# HISTORIC AND DESIGN REVIEW COMMISSION

February 15, 2017

**HDRC CASE NO:** 2017-060  
**ADDRESS:** 510 E MISTLETOE  
**LEGAL DESCRIPTION:** NCB 868 BLK LOT 25 & 30 X 50 STRIP IN REAR  
**ZONING:** R-6  
**CITY COUNCIL DIST.:** 1  
**APPLICANT:** Aliza Lozano/Rockstar homes, LLC  
**OWNER:** Judith & Frederick Bode  
**TYPE OF WORK:** Install porch, modify front opening, window modifications, construct rear addition

**1** SITE PLAN – 2510 SF. BLD.  
SCALE: NTS

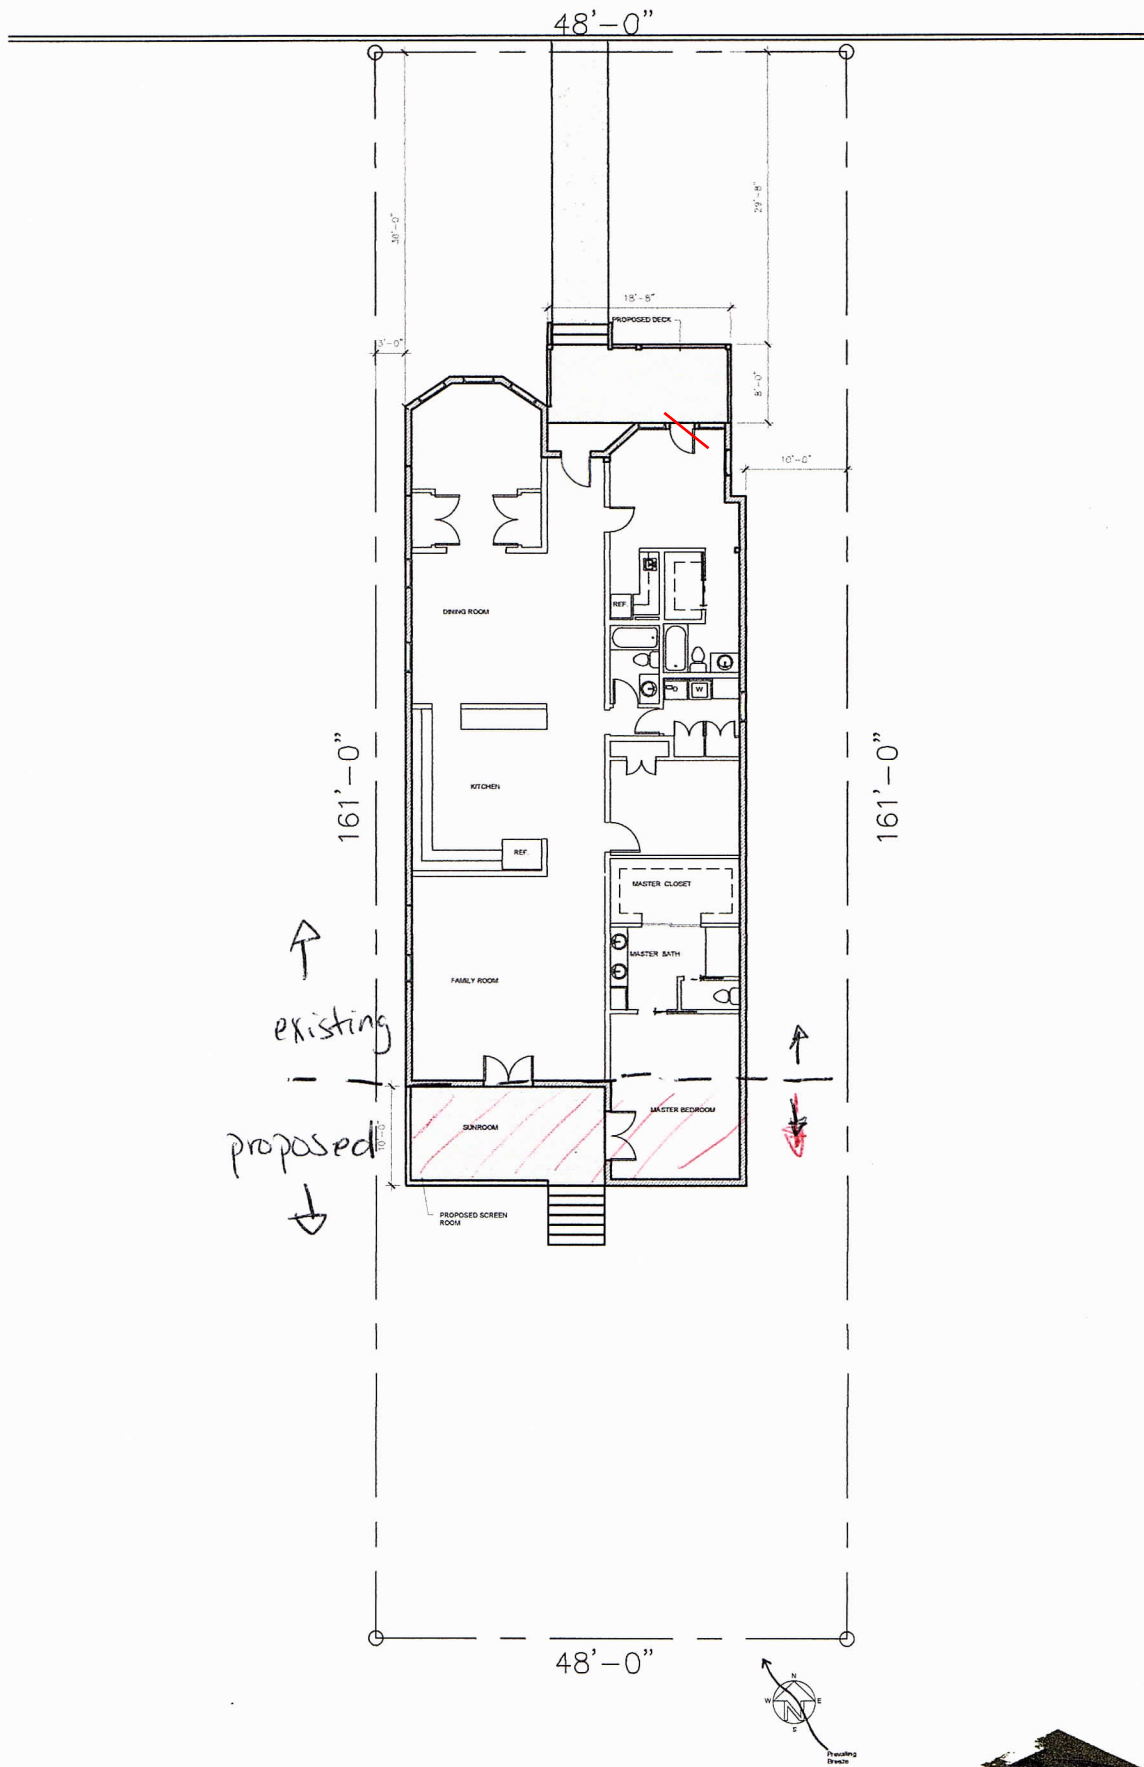
- d. **FRONT PORCH** – The front façade of the house has been previously altered. The original porch has been enclosed, resulting in a small room at the front of the house. Staff has located the structure on the May 1924 Sanborn map which documents the enclosed porch. The proposed new front porch sits in front of the existing enclosure, and extends 8' in front of the house. According to the Guidelines for Exterior Maintenance and Alterations 7.B, new porches should be designed so that they are compatible in scale, massing, and detail while materials should match in color, texture, dimensions, and finish and should be based on the architectural style of the building and historic patterns. The proposed porch design includes traditional elements, including square columns with decorative brackets, a porch balustrade and hand rails along each side of the wood porch steps. These details are consistent with the Guidelines in terms of porch material and architectural details. A front-facing, gabled bay, as found on this house, is characteristic of the Folk Victorian Style. Historically, a front porch would not extend beyond this front bay. The proposed depth of the porch would result in a condition that detracts from the historic building form because the porch would protrude in front of the front bay. This is not consistent with the Guidelines in terms of porch massing and form. A reduced porch depth that does not protrude past the front bay would be more appropriate.

- 1. That the porch depth is reduced so that it does not protrude past the front bay.
- 2. That there is a vertical trim piece or that there is an inset of the addition to indicate the transition between old and new.
- 3. That the existing, original rear windows are salvaged and installed in the rear addition.
- 4. That the windows to be installed in the addition maintain the dimension, profile, and configuration of the originals, feature clear glass, maintain the original appearance of window trim and sill, and be inset at least two inches.
- 5. Submit a window detail to staff prior to receiving a Certificate of Appropriateness
- 6. That these details be submitted to staff prior to receiving a Certificate of Appropriateness.

**1 FLOOR PLAN**  
SCALE: 1/8" = 1'-0"

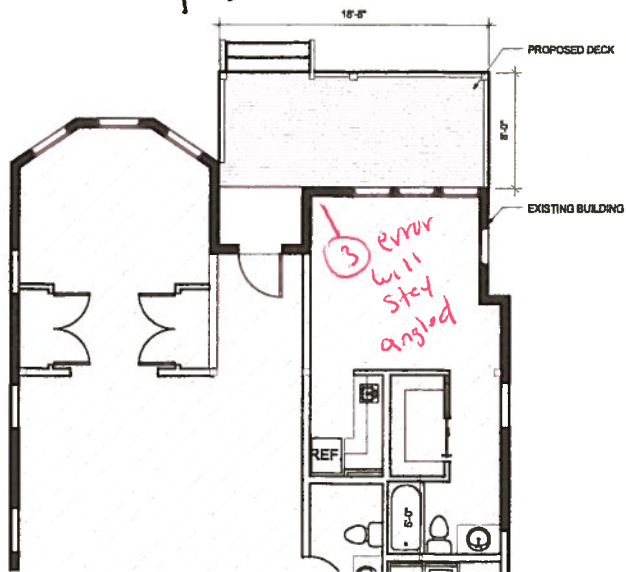
- c. **FRONT DOORS** – The existing two wood front doors are in its original location. The proposed new location for the front door entrance would move it up approximately 4' to be closer in line with the front façade. The second front door is proposed to be removed and enclosed with new siding to match existing. According to the Guidelines for Exterior Maintenance and Alterations 6.A.i, original door openings should be preserved and not be filled in. Staff finds the proposal is not consistent with the Guidelines, and both door openings should be retained.

## 5 EAST ELEVATION

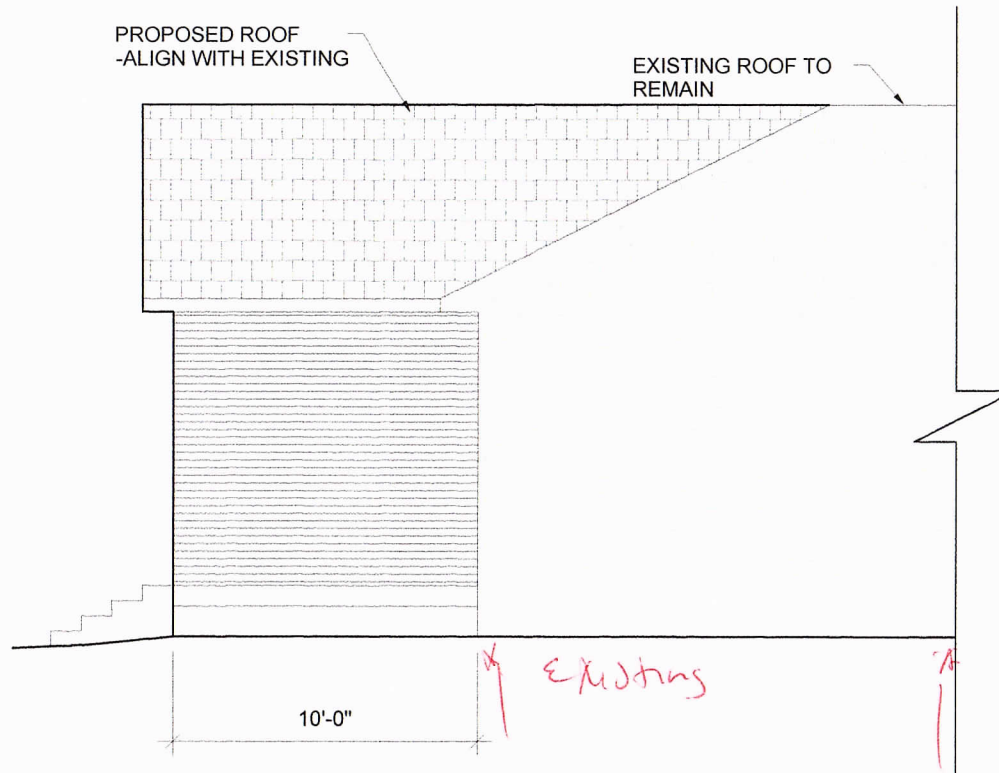
- f. **TRANSITION** – The proposed addition is in line with the left and right façade. According to the Guidelines for Additions 1.A.iv., the addition should feature a visual distinction between old and new building forms, whether it is an offset of the material or an architectural element. Staff finds the proposed addition not consistent with the Guidelines in terms of featuring a transition. Staff recommends that there be a vertical trim piece distinguishing between old and new, or that there be an inset of the addition.

# **4** WEST ELEVATION

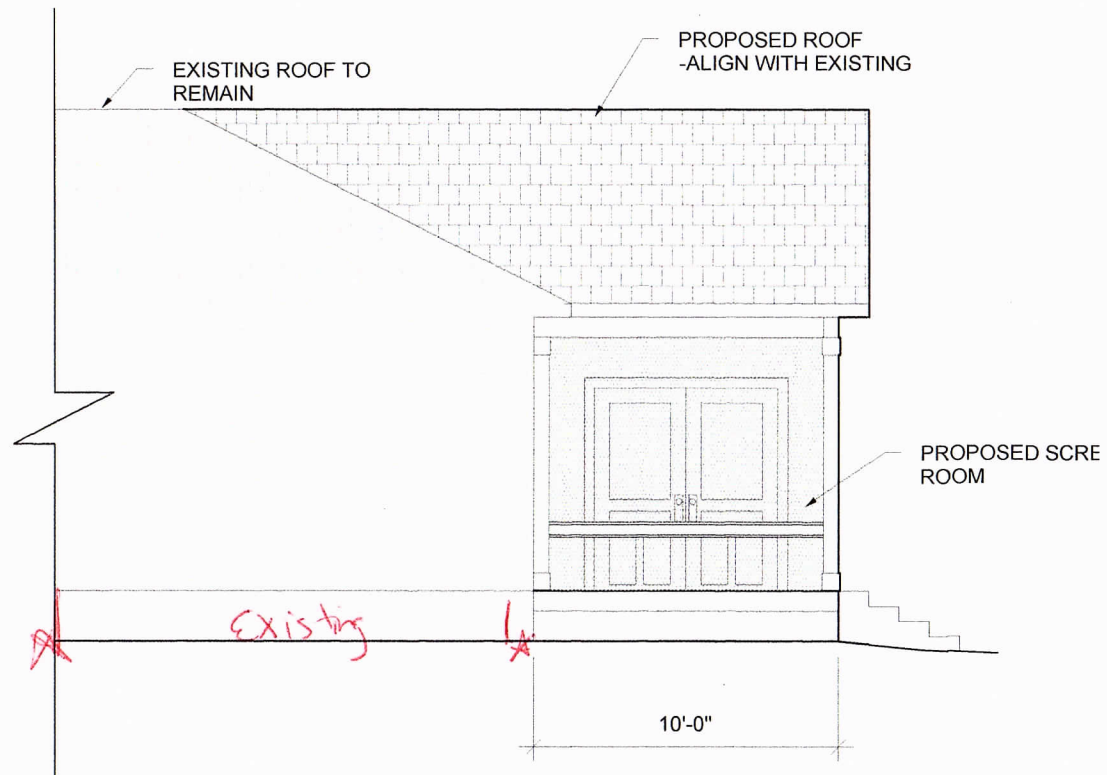
- i. **WINDOWS/DOORS** – The proposed addition features two over two windows with same profile as existing, two sets of double doors each with half window lights, and one single door with a full light and a transom window. According to the Guidelines for Additions 4.A.ii., the addition should incorporate architectural details that are in keeping with the style of the original structure. Staff finds the proposed windows and doors are characteristic of the original structure, however salvaging the existing rear windows would be more appropriate.

- j. **MATERIALS** - The proposed addition features wood lap siding, aluminum screen panels for the screened in porch, composition shingle roofing. The proposed doors are steel and the windows are vinyl. The material on the face of the rear gable will be wood lap siding to match existing. According to the Guidelines for Additions 3.A., addition materials should match in type, color, and texture, and be compatible with the architectural style and materials of the original structure. Staff finds the proposed siding, screening, and roofing materials are consistent with the Guidelines in terms of color, type, texture and are compatible with the style of the original structure. Vinyl windows and steel doors are not consistent with the Guidelines. Wood windows and wood doors would be most appropriate.

EXISTING FLOORPLAN

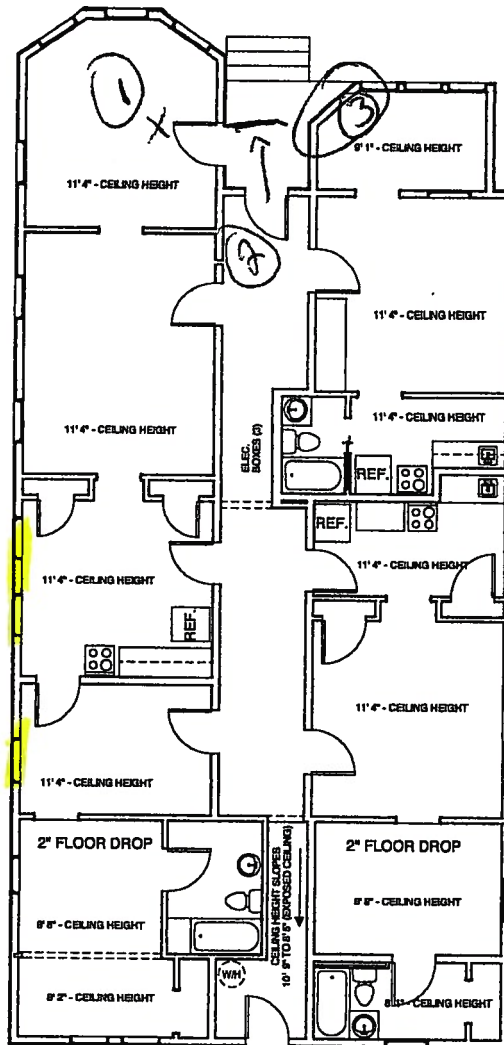
- b. **WINDOWS** – There is one double window, with two 2 over 2 dividing lights, and one two over two wood window on the right façade. The proposal is to remove these windows and enclose the frames with siding to match the existing. According to the Guidelines for Exterior Maintenance and Alterations 6.A.i, original window openings should be preserved and not be filled in. Staff finds the proposal is not consistent with the Guidelines, and the window openings should be retained.

- windows  
to be  
removed

Staff does not recommend approval of items # 1 and #2 based on findings a through c. Window and door openings should be retained.
